TRANS/WP.29/GRSP/2002/6
1 March 2002

World Forum for Harmonisation of Vehicle Regulations (WP.29)

PROPOSAL FOR DRAFT AMENDMENTS TO REGULATION No. 95
(Lateral protection collision)

Transmitted by the Expert from the European Enhanced
Vehicle-safety Committee (EEVC)

Blocks 1 & 3
Figure 2a

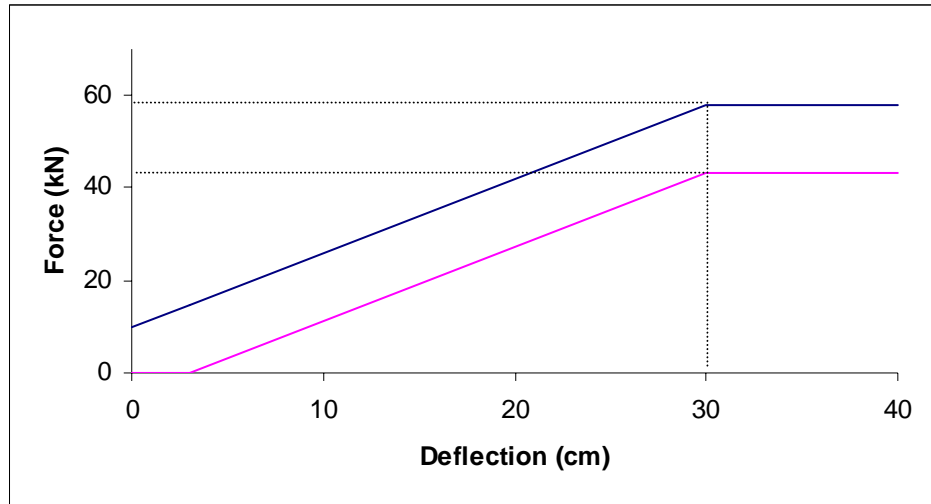
- 2.1.5.4. Blocks 1 and 3 are identical. Their rigidity is such that their force deflection curves fall between corridors of figure 2a.
- 2.1.5.5. Blocks 5 and 6 are identical. Their rigidity is such that their force deflection curves fall between corridors of figure 2d.

- 2.1.5.10. The dissipated energy $\frac{1}{2}$ against blocks 1 and 3 during the test shall be equal to 9.5 ± 2 kJ for these blocks.
- 2.1.5.11. The dissipated energy against blocks 5 and 6 during the test shall be equal to 3.5 ± 1 kJ for these blocks.

[NOTE: the values of energy absorption for only blocks 1&3 and 2 differ from that in the existing Regulation 95]

Block 2
Figure 2b

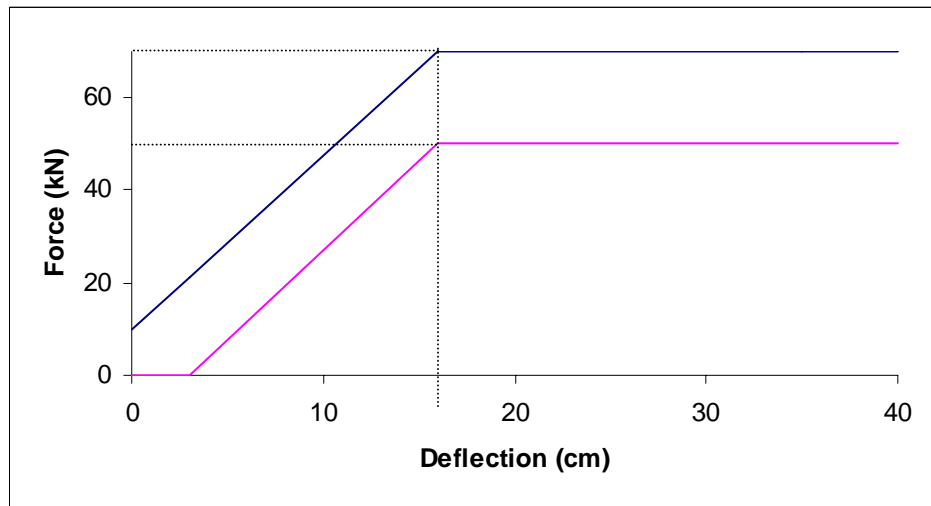
- 2.1.5.6. The rigidity of block 2 is such that its force deflection curves fall between corridors of figure 2b.
- 2.1.5.7. The rigidity of block 4 is such that its force deflection curves fall between corridors of figure 2c.

- 2.1.5.12. The dissipated energy against block 4 shall be equal to 4 ± 1 kJ.
- 2.1.5.13. The dissipated energy against block 2 shall be equal to 15 ± 2 kJ.
